ECE/TRANS/WP.29/GRRF/2007/15  
13 July 2007

Development of the draft global technical regulation on Electronic Stability Control

Proposed amendments to draft global technical regulation on Electronic Stability Control

Submitted by the expert from Hungary

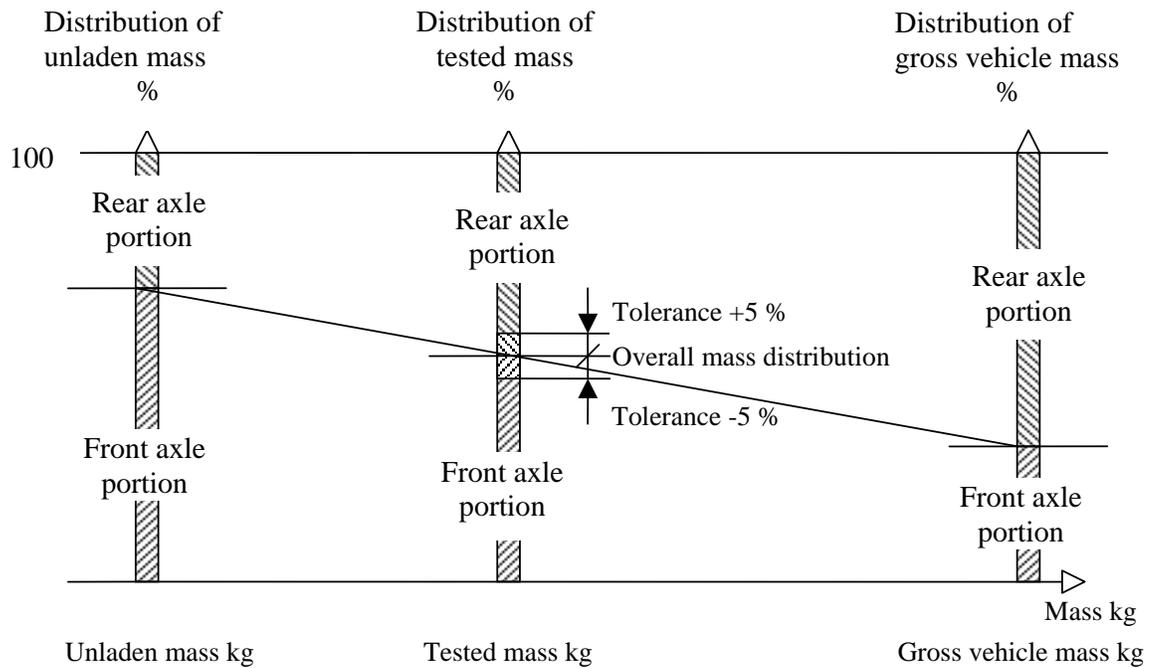
**6.3.4. Overall mass distribution. The overall mass distribution, subject to ±[5 per cent] tolerance, of the tested mass resulting from the unladen mass, from the total interior load as in paragraph 6.3.2., from the mass of the outriggers (if any) and from the mass of the subframe (if any) as in paragraph 6.3.3. shall be set upon the following chart.**

The proposal does not specify how to determine the distribution of the gross vehicle mass in fully laden state. Usually, the maximum axle loads are not reached when fully laden. Rather, the maximum legal payload is distributed in a practical way (68 kg people on the seats, the rest evenly distributed in the luggage compartment), and the ratio of the resulting axle loads to the fully laden mass represents the load distribution percentage. A precise description of the realisation of this principle is found e.g. in the appendix of European Union Directive 92/21/EC. Similarly to the draft text, the variability of the height of the centre of gravity is not addressed.
